Date: February 1, 1995
To: X3T10 Membership
From: John Lohmeyer
Subject: Minimum Negation Current Issue with Fast-20

6.1.2 Single-ended output characteristics

Figure 1 -- Active Negation Current vs. Voltage

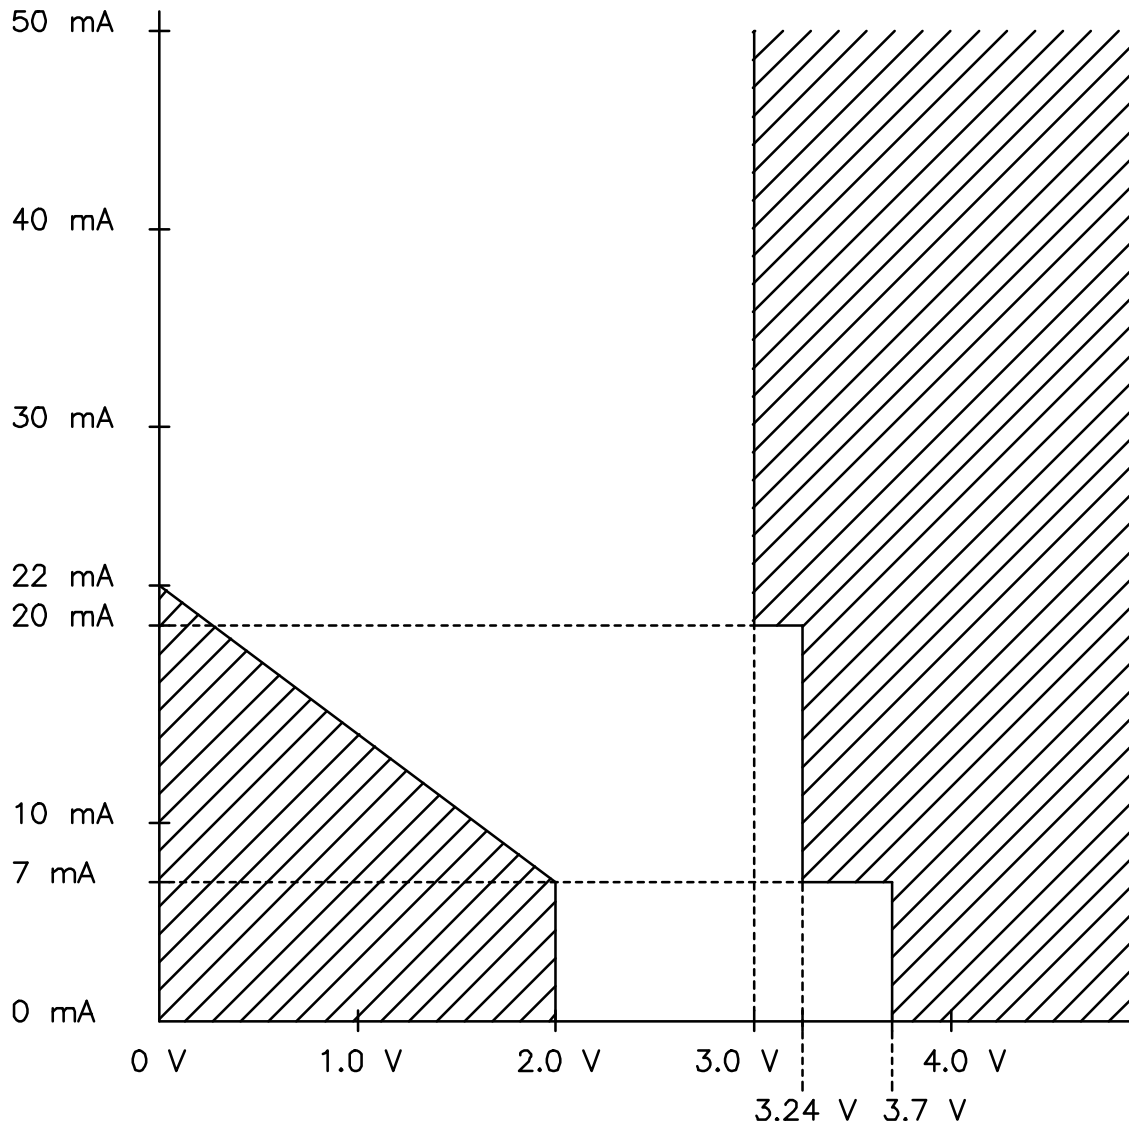
Revision 1 of this proposal changes the V-I plot in figure 1 to raise the minimum negation current at 2.0 volts to 7 mA from 0 mA. It also adds "d.c." to the last line of the first paragraph in 6.1.2 -- this is to clarify that the V-I plot does not apply to a.c. characteristics. The rest is unchanged.

After reading the SCSI Reflector messages on this topic and discussing the topic with our chip designers, I'd like to propose that section 6.1.2 be modified as shown in the document. It would replace items c), d), and e) from the output characteristics list with a new item c):

Figure 1 is new. It has the same characteristics for the old items c) and d) and reduces the drive requirements from the old item e) to a linear function going from points (0 V, 22 mA to 2 V, 0 mA).

"c) The output sourcing characteristics (signal negated) shall be constrained to operate in the non-shaded areas of figure 1."

- a) VOL (low-level output voltage) = 0,0 to 0,5 V d.c. at IOL = 48 mA (signal asserted);
- b) VOH (high-level output voltage) = 2,5 to 3,7 V d.c. (signal negated);
- c) The output sourcing characteristics (signal negated) shall be constrained to operate in the non-shaded areas of figure 1.
